## HISTORIC AND DESIGN REVIEW COMMISSION

June 06, 2018

**HDRC CASE NO:** 2018-190  
**ADDRESS:** 1910 E HOUSTON ST  
430 N MONUMENTAL  
129 FLORENCE ALLEY  
**LEGAL DESCRIPTION:** NCB 1372 BLK 4 LOT 1&2  
NCB 1372 BLK 4 LOT 3 & N 20 FT OF 4  
NCB 1372 BLK 4 LOT E 75 OF S 20 OF 4, E 75 OF 5 OR 4B & 5B  
**ZONING:** C-2, RM-4  
**CITY COUNCIL DIST.:** 2  
**DISTRICT:** Dignowity Hill Historic District  
**APPLICANT:** L. Shannon O'Malley  
**OWNER:** L. Shannon O'Malley  
**TYPE OF WORK:** Construction of four, two story, single family residential structures  
**APPLICATION RECEIVED:** May 15, 2018  
**60-DAY REVIEW:**  
**REQUEST:**

The applicant is requesting a Certificate of Appropriateness for approval to construct four, two story, single-family residential structures on the vacant lots bounded by N Monumental, E Houston and Florence Alley. The lots included are numbered 40, 41, 47 and 48.

COLUMN DETAIL

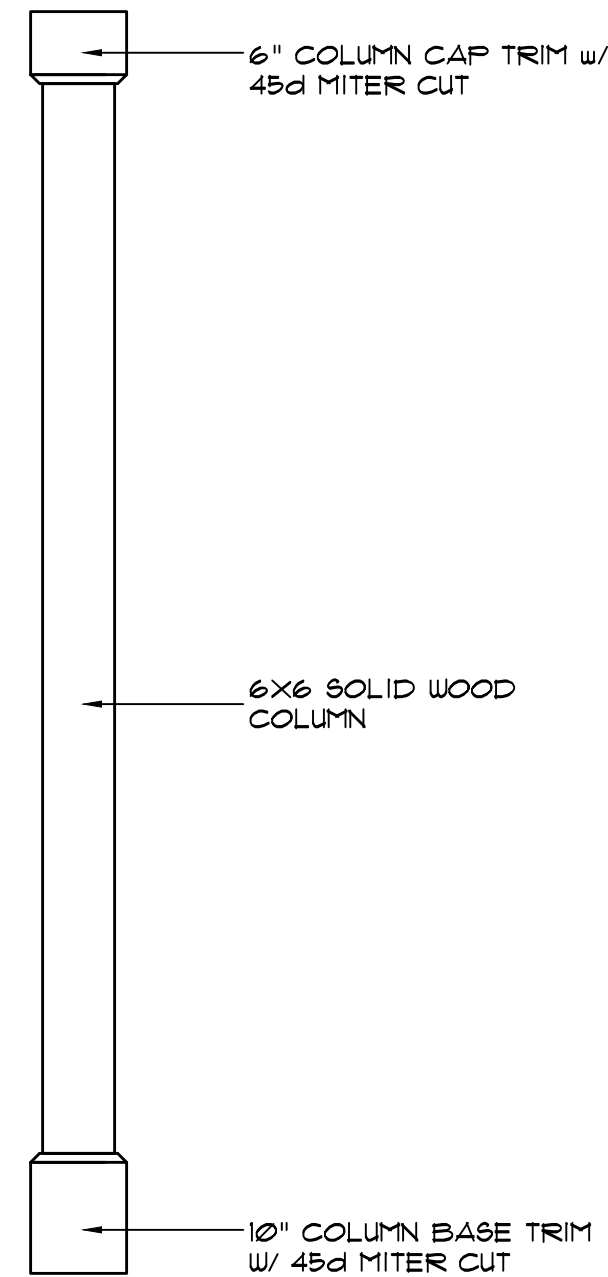
- v. That column details be submitted to staff when returning for final approval. **The applicant has provided a column detail to staff.**
  - vi. That gable returns/soffit boxes be eliminated. **The applicant has revised construction documents to note this change.**

v. That column details be submitted to staff when returning for final approval as noted in finding m.

- k. **PORCH DESIGN** – The applicant has proposed for the proposed structures that front E Houston to have wrap around porches to address both street fronts. Staff finds this to be appropriate. Additionally, staff finds the proposed porch massing of each structure generally appropriate. Each porch features recessed massing and a porch structure that is integrated into the overall massing of the structure. Columns should feature a dimension of at least six inches square and should feature capital and base trim. The applicant has submitted a column detail noting 6 x 6 columns with both column and base trim.

Please detail on elevation sheets.

Front Elevation - NORTH

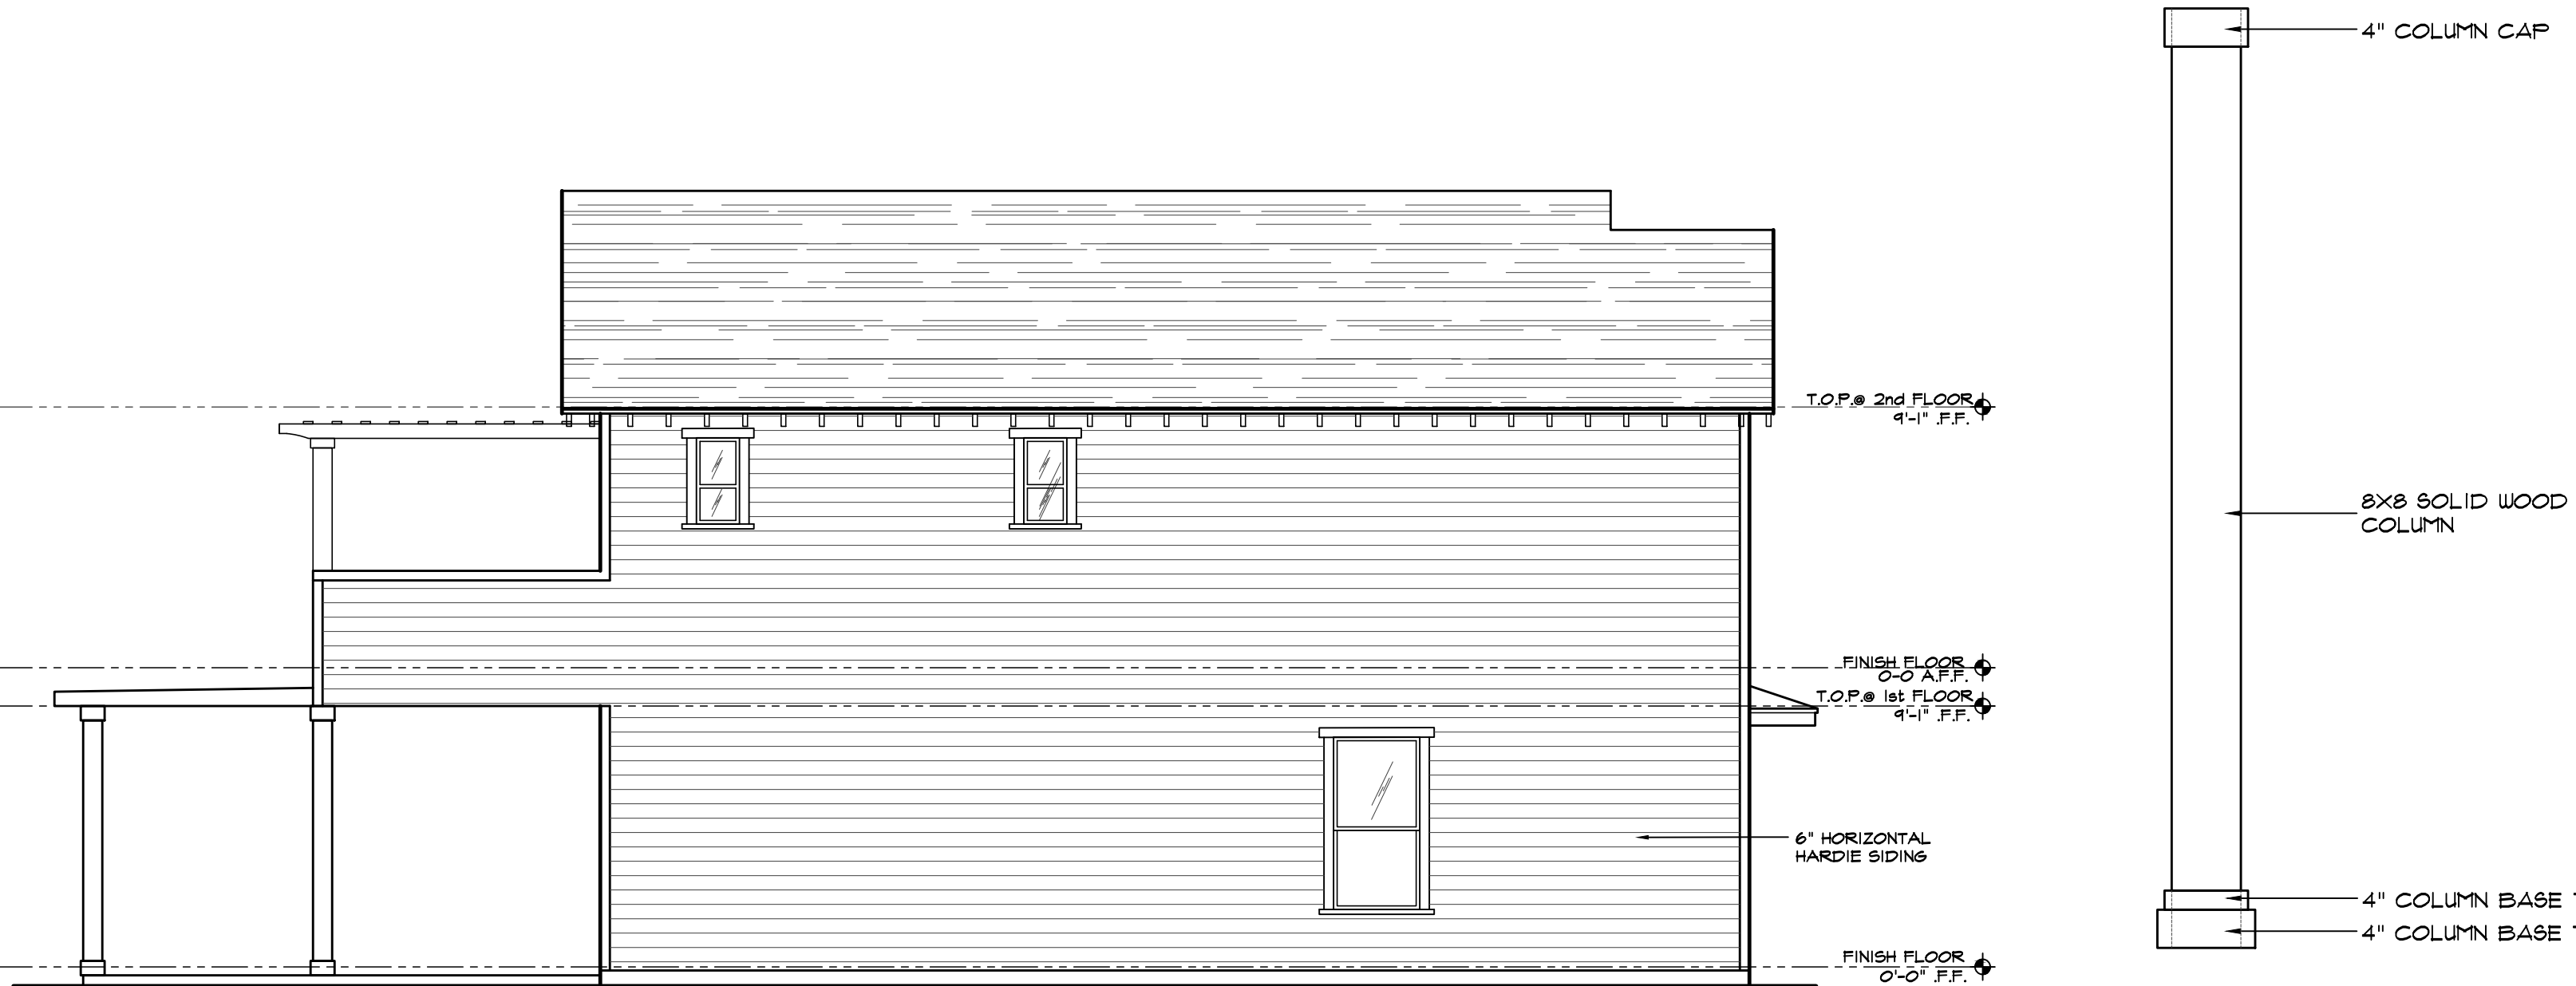
- vii. That the proposed new construction on lot 48 feature a transom window above the proposed front door and a window or door on both levels one and two where the wraparound porch terminates. The proposed new construction on lot 47 should feature a smaller window adjacent to the front door, or a centered door with side lites and a transom window. All transom windows should feature divided lites. **The applicant has revised construction documents to note these changes.**

vii. That the proposed new construction on lot 48 feature a transom window above the proposed front door and a window or door on both levels one and two where the wraparound porch terminates.

Request has been drawn in on Lot 48 front elevation. Second level only has access to patio on West elevation.

Front Elevation - WEST

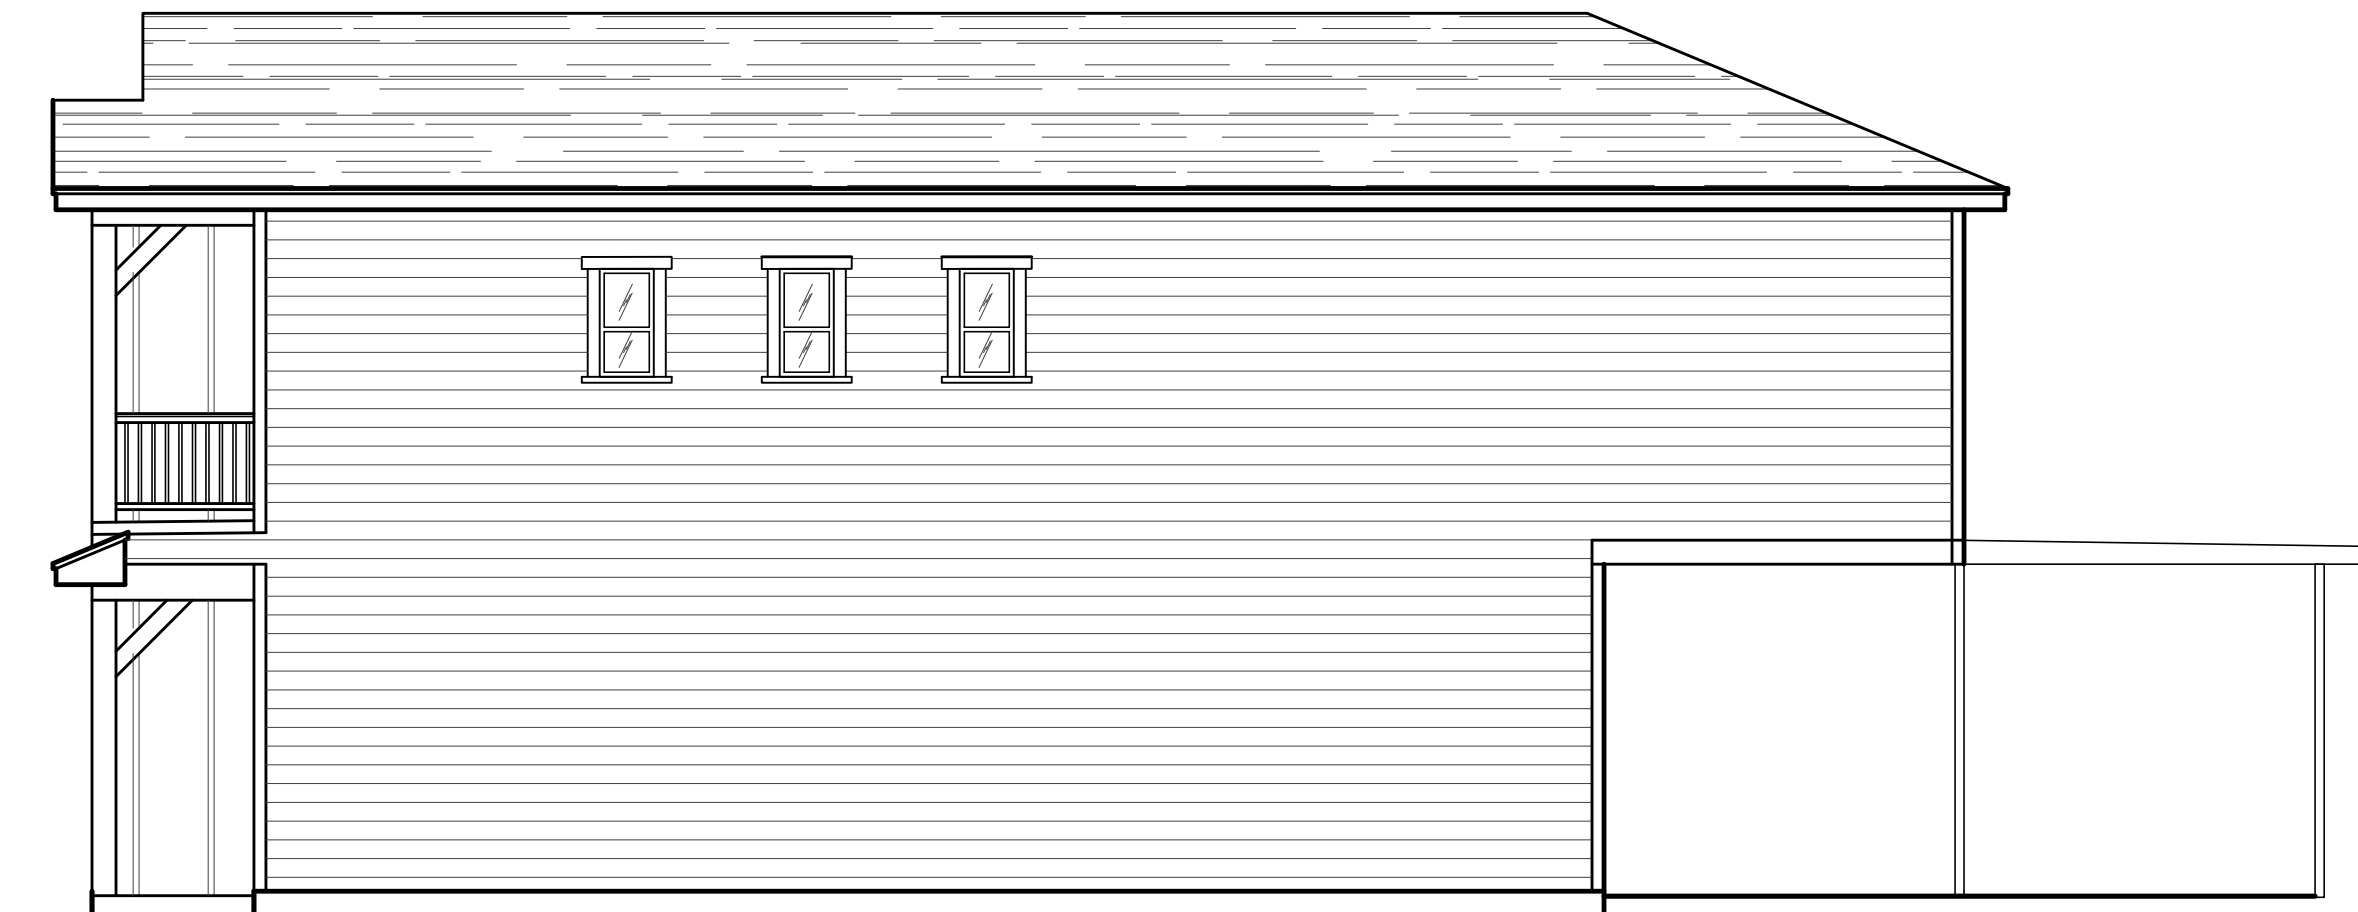
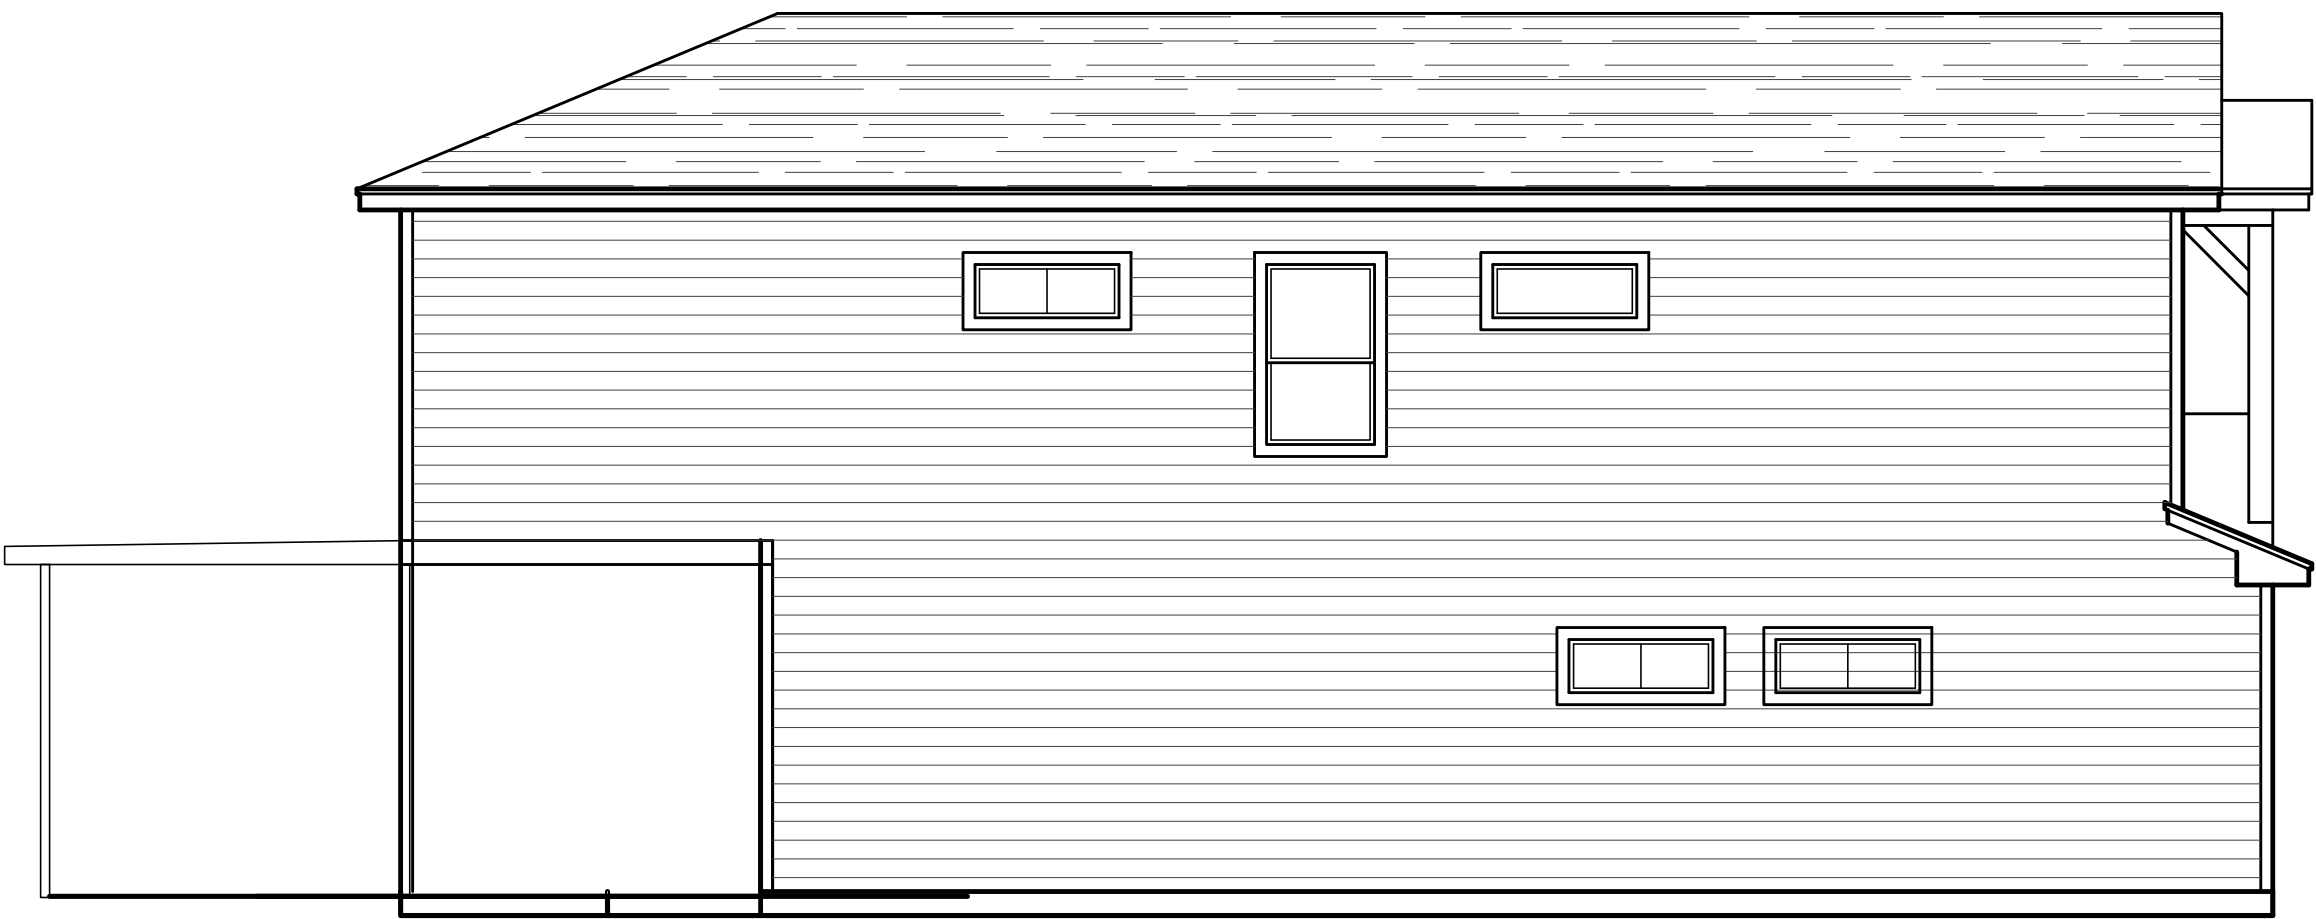
vij. The proposed new construction on lot 47 should feature a smaller window adjacent to the front door, or a centered door with side lites and a transom window. All transom windows should feature divided lites.

Request has been drawn in for elevation at Lot 47
